Stage 1 Road Safety Audit

**Proposed Housing Development at Robbers Lane,
Maugheraboy, Sligo**

On behalf of Sligo County Council

3.2.1 Development Road Alignment

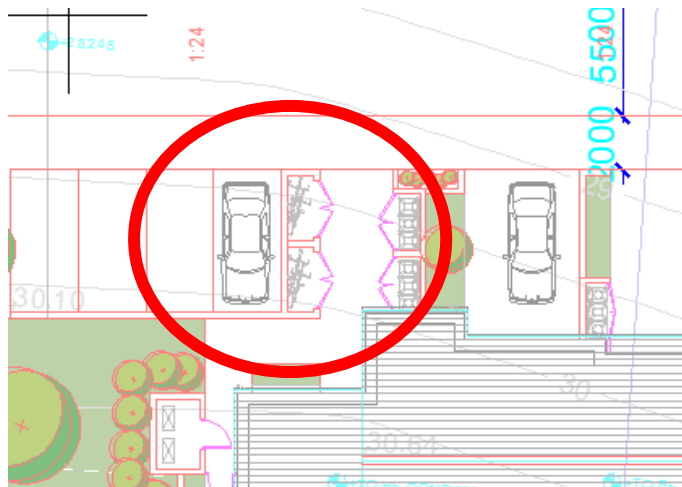
Problem: The development consists of 2 straight streets. The North Cul-de-sac is 120m long and 5.5m wide, the South Cul-de-sac is 120m long and is also 5.5m wide. Roads of this character have poor history of high vehicle speeds.

Hazard: Children playing in the road or pedestrians crossing the road are at risk of impact from high-speed vehicles.

Recommendation: Amend the layout, ideally by changes to the horizontal alignment to encourage slow vehicle speeds.

3.2.1 Development Road Alignment	YES	YES Tabletops have been added to the north and south cul-de-sac junctions with Robbers Lane and a traffic calming ramp will be added halfway along the southern cul-de-sac at a pedestrian crossing point.

3.2.3 Pedestrian Railing at Post Office

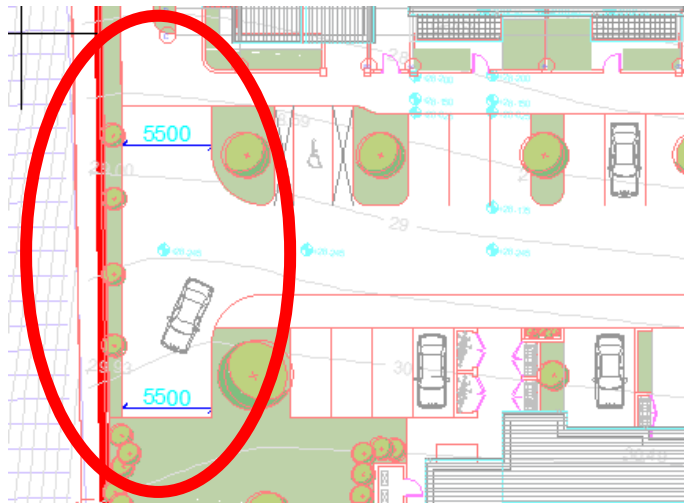
Problem: The proposals include for replacement of the existing pedestrian railing at the post office with "Visirail" railing.

Hazard: The "Visirail" system consists of series of angled vertical bars that generally permit drivers who are travelling parallel to a footpath to see pedestrians on the footpath. The problem at this

junction is Lyndale exiting drivers' inability to see vehicles approaching from their left on Maugheraboy Road/Church Hill. There is risk that the change of railing at this location may make no improvement or possibly worsen the visibility issue at this location.

Recommendation: Ensure the chosen railing permits see through to the Maugheraboy Road/Church Hill traffic.

3.2.2 Bin Stores	YES	YES Design to be adjusted at detail design and provided at Construction Stage to ensure adequate visibility as recommended		
3.2.3 Pedestrian Railing at Post Office	YES	YES: to be included in tender drgs and provided: Construction Stage

3.3.2 Parallel Car Parking Spaces – South-eastern corner

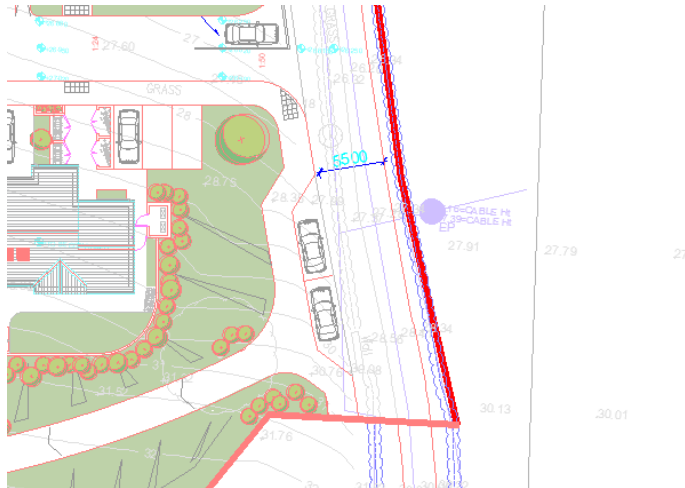
Problem: Two parallel car parking spaces are indicated in the south-east corner of the side. It is not clear how entry/exit to these spaces is intended to be achieved as there is no space provided for the driver to turn the vehicle.

Hazard: There is risk that the driver will reverse up to the southern cul-de-sac in order to undertake a turn in the mouth of this junction. Impact with vehicles exiting the cul-de-sac may occur.

Recommendation: Amend these spaces to be perpendicular.

3.3.1 Pedestrian Desire line Southern cul de sac	YES	NO	NB A new road crossing has been included the part 8 Planning proposals	YES
3.3.2 Parallel Parking at South Eastern Corner	YES	NO	NB These spaces have been omitted from the part 8 Planning proposals	YES

3.3.3 North Cul-de-sac : Junction Visibility

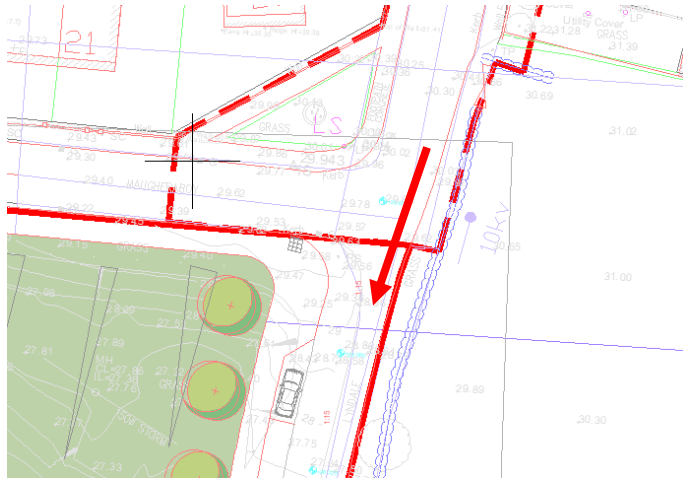
Problem: There are a number of car parking bays to the south of the northern cul-de-sac junction. High sided vehicles parked in these bays may restrict visibility for drivers attempting to exit the cul-de-sac.

Hazard: Drivers may errantly exit the cul-de-sac into the path of oncoming vehicles.

Recommendation: Ensure adequate junction visibility is provided.

3.3.3. Junction Visibility Northern Cul-De-Sac	YES	YES Parking layout has been adjusted to allow sight lines		
3.3.4 Connection existing estate road	YES	YES Footpath to be amended recommended

3.3.5 Connection with Existing Estate Road – Exiting Traffic

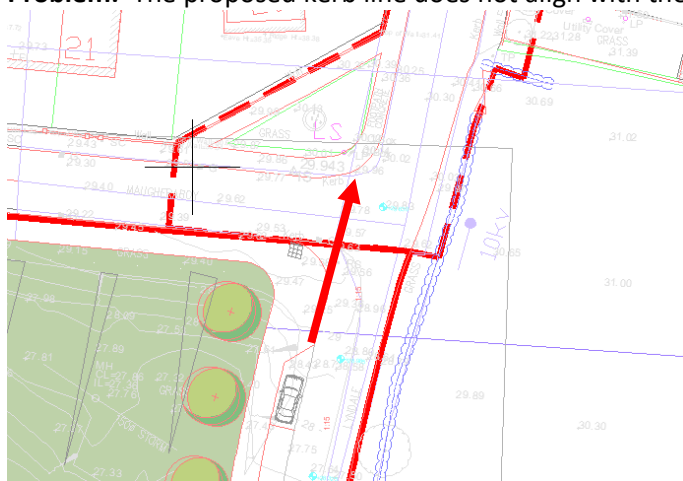
Problem: The proposed kerb line does not align with the existing estate road kerb line.

Hazard: Users exiting the new development may strike the kerb at the far side of the junction.

Recommendation: Amend the road layout to ensure a smooth driving line.

3.3.5 Connection existing estate road	YES	YES Footpath to be amended recommended		
3.3.6 North Cul de sac Pedestrian Visibility	YES	YES Planting has been omitted as recommended

3.3.9 Table-Top Junction – Church Hill - Eastern Arm

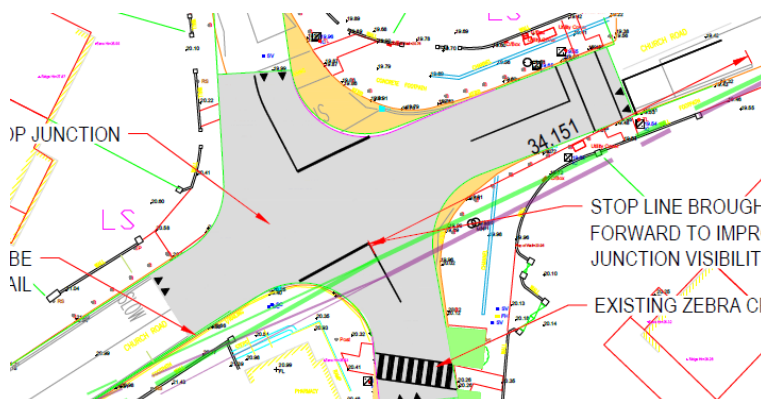
Problem: The proposed ramp up to the table-top is located immediately adjacent to the signalised crossing.

Hazard: Drivers’ attention may be drawn to the ramp and diverted from pedestrians commencing a crossing here. Additionally sight impaired pedestrians may wander onto the ramp and stumble/fall.

Recommendation: Relocate the ramp further in advance of the crossing. It is recommended this is a minimum of 1 car length.

3.3.8 Table Top Junction Robbers Lane and Church Hill	YES	YES Ramp has been relocated as recommended, outside zone of zig zag markings		
3.3.9 Table Top junction Church Road, Maugherboy	YES	YES Ramp has been relocated as recommended

3.3.11 Robber's Lane Car Parking Bay

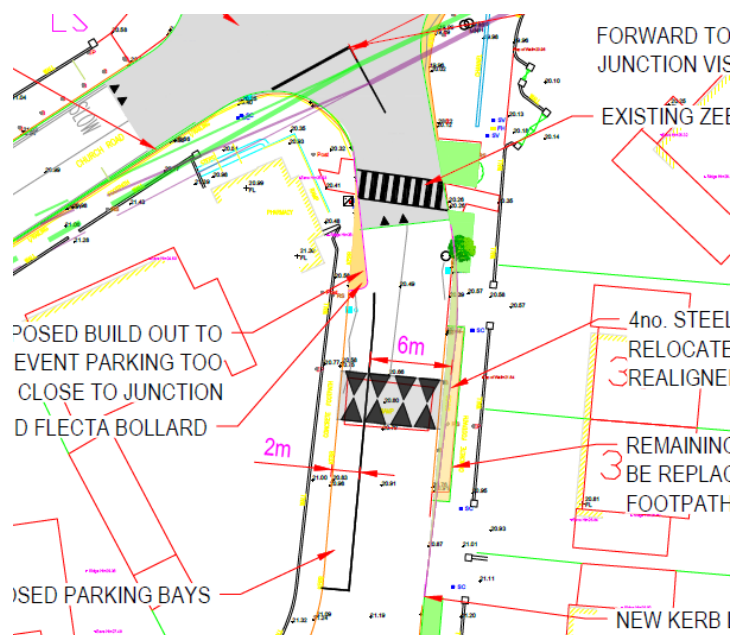
Problem: The proposals introduce a formal car parking bay to the western side of Robbers Lane. This bay is in close proximity to the zebra crossing.

Hazard: High sided vehicles parked in this bay are likely to restrict visibility to/from pedestrians on the western side of the zebra crossing. Additionally, the car parking bays overlap with the zone for zig-zag road markings.

Recommendation: Omit car parking that may interfere with intervisibility to/from pedestrians. This can be assumed to be the zone of zig-zag markings.

3.3.10 Maugherboy Rd Centreline	YES	YES Road Centre line has been included as recommended		
3.3.11 Robbers Lane Parking bay	YES	YES Parking bays have been omitted as recommended

3.3.12 Robbers Lane Road Hump

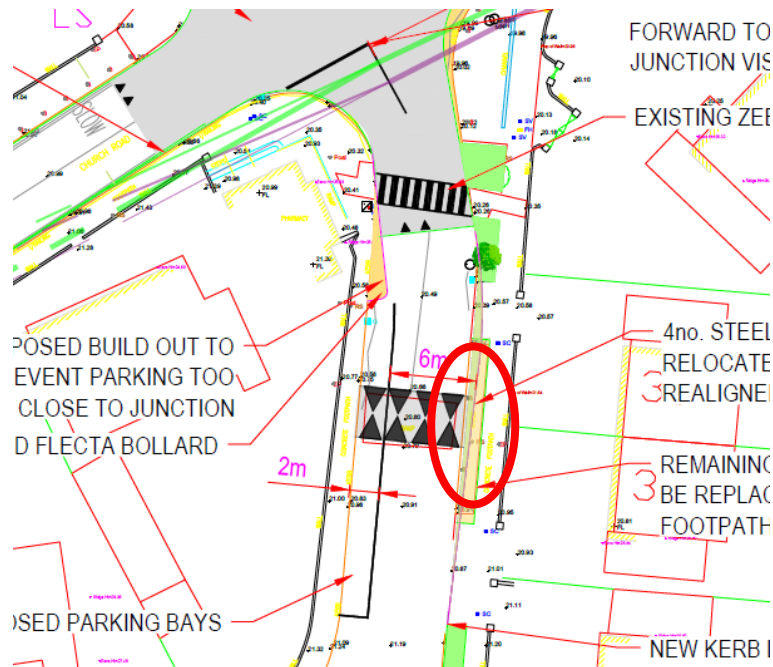
Problem: The road in the area of the existing road hump is proposed to be widened. There are no proposals to extend the road hump to abut the revised kerb.

Hazard: Two-wheeled vehicles may attempt to avoid the road hump by travelling in the area of widened road. These users may errantly strike either the edge of the road hump or the kerb and lose vehicle control.

Recommendation: Extend the road hump to meet with the revised kerb.

3.3.12 Robbers lane Hump	YES	YES Road hump has been removed and table top extended		
3.3.13 Robbers Lane: Footpath build out taper	YES	YES Footpath build out and taper has been included as recommended

3.3.13 Robbers Lane – Footpath Build Out – Taper

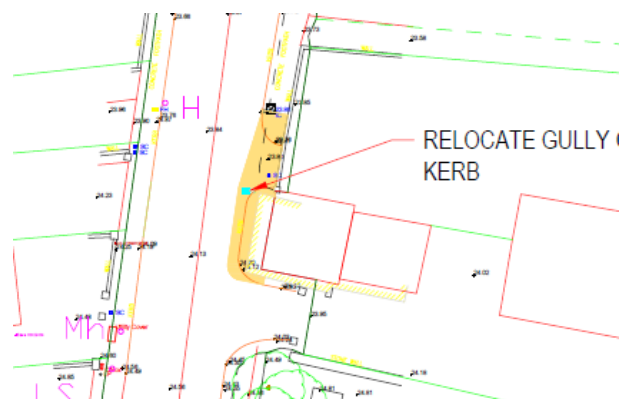
Problem: The taper to the widened footpath is very short.

Hazard: Users may impact with the kerb and lose vehicular control.

Recommendation: Extend the “taper” to the build out to provide a smooth driving line.
